Access Compliance Report

Public Rights-of-Way

Intersection ID: 24090	Main Street: CHAMEROY_CT	Cross Street: HAWK_CREST_CT	Location:	N
ADA ID: E993F3296FDA	Ramp Type: PerpDiag	Initial Pass/Fail: Fail	Overall Compliance: No	Severity Score: 25

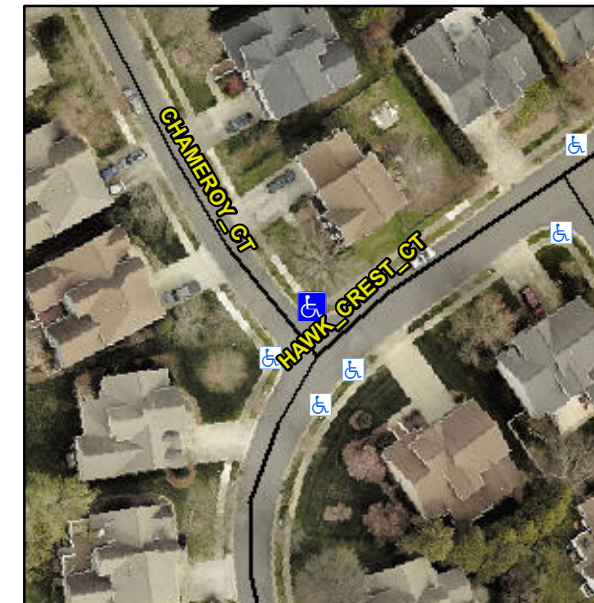
Not Found, R304.2.2, R304.5.3

Compliance	Description	Data	Compliance	Description	Data
N/A	Ramp Length (in)	47.0	No	Ramp Slope (%)	11.4
Yes	Ramp Width (in)	48.0	No	Ramp XSlope (%)	6.8
N/A	Flare Type LT	N/A	N/A	Flare Type RT	N/A
N/A	Flare Slope LT (%)	N/A	N/A	Flare Slope RT (%)	N/A
N/A	Flare Traversable LT?	N/A	N/A	Flare Traversable RT?	N/A
N/A	Landing Length (in)	N/A	N/A	DWS Provided?	N/A
N/A	Landing Width (in)	N/A	N/A	DWS Contrast?	N/A
N/A	Landing Slope (%)	N/A	N/A	DWS Length (in)	N/A
N/A	Landing X Slope (%)	N/A	N/A	DWS Full Width?	N/A
N/A	Landing Curb? (Y/N)	N/A	N/A	DWS Offset (in)	N/A
N/A	Shared Landing?	N/A			
N/A	Gutter Ponding?	N/A	N/A	Gutter Slope (%)	N/A
N/A	Gutter Lip Ht (in)	N/A	N/A	Gutter X Slope (%)	N/A
N/A	Painted X Walk1?	No	N/A	Painted X Walk2?	No
	X Walk 1 Direction	To SW		X Walk 2 Direction	To SE
N/A	X Walk 1 Width (in)	N/A	N/A	X Walk 2 Width (in)	N/A
	X Walk 1 Slope (%)	1.4		X Walk 2 Slope (%)	7.7
	X Walk 1 X Slope (%)	3.5		X Walk 2 X Slope (%)	4.1

Remove & Replace Curb Ramp With Two New Directional Ramps or Equivalent.
